City of Kingsburg

KINGSBURG CITY COUNCIL

PLANNING COMMISSION

North Kingsburg Specific Plan Items For Discussion

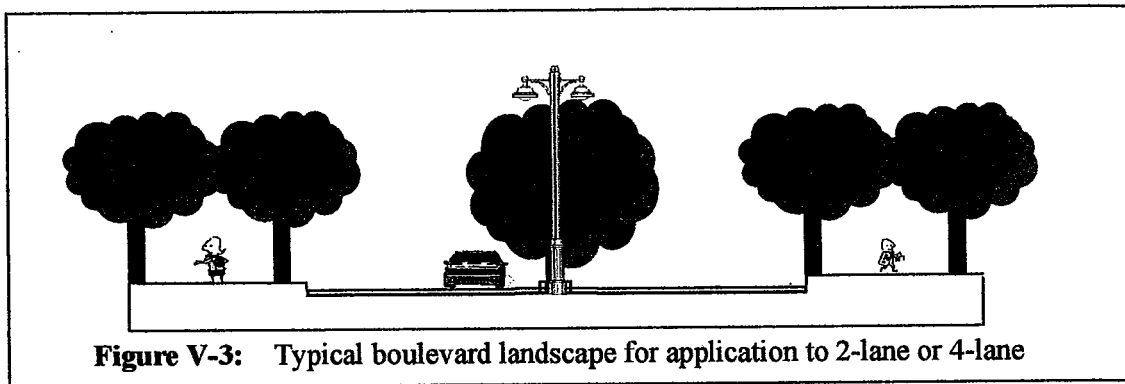
1. Page V-1: Design concepts will be amended from time to time based upon innovation or changing context of development
 - **Impact:** Has the potential to determine how individual projects are viewed in terms of market conditions. Also may NOT require amendment to the NKSP
